REQUEST

Current Zoning: R-3 (single family residential)
Proposed Zoning: R-8MF(CD) (multi-family residential, conditional)

SUMMARY OF PETITION

**STAFF
RECOMMENDATION**

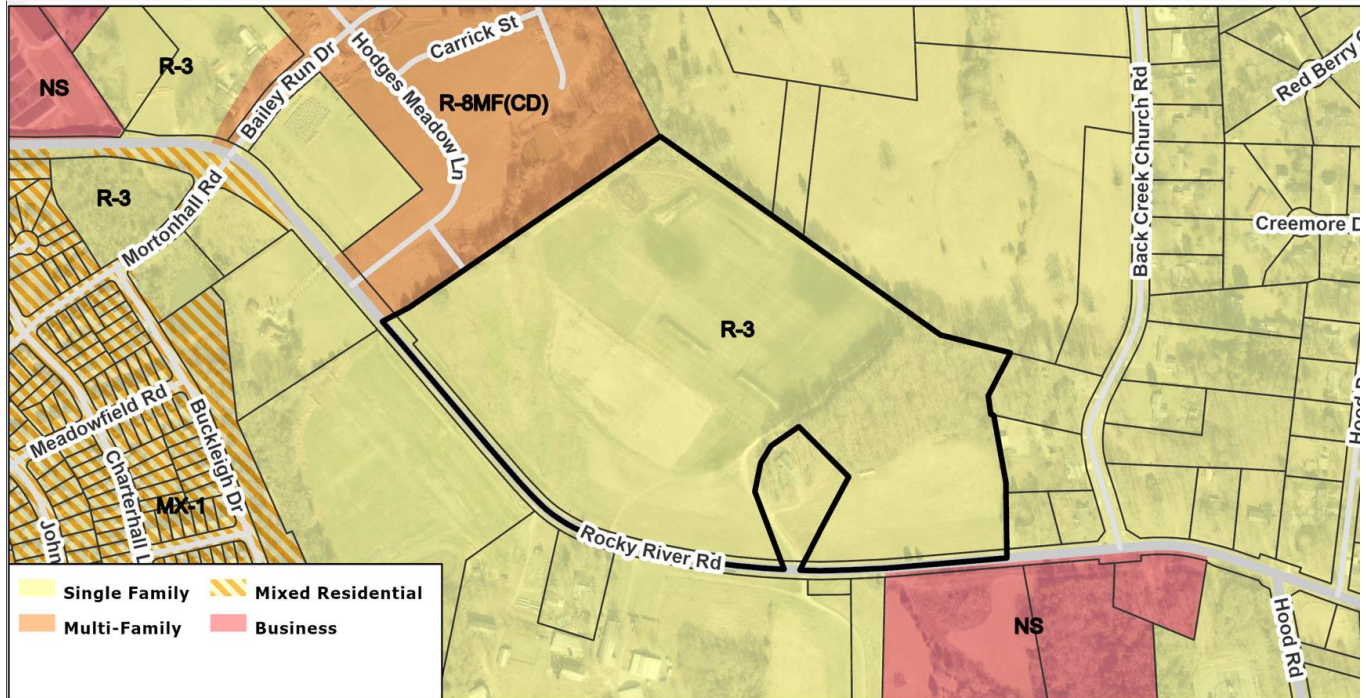
1. 4-foot Median is to be constructed on Rocky River Road. Label, dimension, and commit to proposed median.

2. The proposed berm shall be removed from the park dedication area.
3. The note needs to be revised to state that the 1.5 acres proposed park shall be dedicated and conveyed to Mecklenburg County for a future neighborhood park.
4. The site data table shows 15% tree save but there is not 15% show on the plans. Site is located in a wedge so a min of 15% of the overall site is required to be shown as tree save.

5. Specify if townhomes are to be "land for sale".
6. Add townhomes to proposed use.
7. Add to site data table: density allowed, density proposed, number of units allowed, number of units proposed.

8. Future Eastern Circumferential Road. Because of the road type setback should be discussed with staff.
9. Show and label required side and rear yards based on building orientation. This applies to the overall property boundaries not the sublots.

10. The site must meet all planned multi-family requirements.
11. Setbacks and yards are based on planned multi-family requirements. Note as follows:
 - Setback along Rocky River Road = 30ft.

- Setback along Local Streets = 27ft.
 - Setback along Future Eastern Circumferential Road = contact staff for setback prior to resubmittal of rezoning

- Rear Yard = 40ft. or 50ft. if adjoining single family developed or zoned land
 - Side Yard = 10ft. or 20ft. if adjoining single family developed or zoned land

12. Show and label setbacks along all public streets.
13. Please clarify if this the minimum 50% open space required for R-8MF—if so remove useable common.

14. Sublots cannot be in the buffers.
15. Buffers start at the setback.
16. If any buffers are being reduced it must be noted.
17. The 20-foot garage setback is measured from the back of sidewalk or right-of-way whichever is greater is a reduced setback is used along local streets.

18. Building separation is a minimum of 16 feet.
19. The 27ft. setback can be reduced to 15ft. per section 9.303(19)(f) of the zoning ordinance if all conditions of that section are met but all garages must meet the 20ft. setback. All corner lots must also meet all requirements (including an entrance doorway on both side) if the 15ft.setback is being used. If the reduced setback is to be used this information must be noted in the site data table.

20. Please clarify if the proposed pathway internal to the development is intended to have connections to the parking lot abutting the proposed public park.
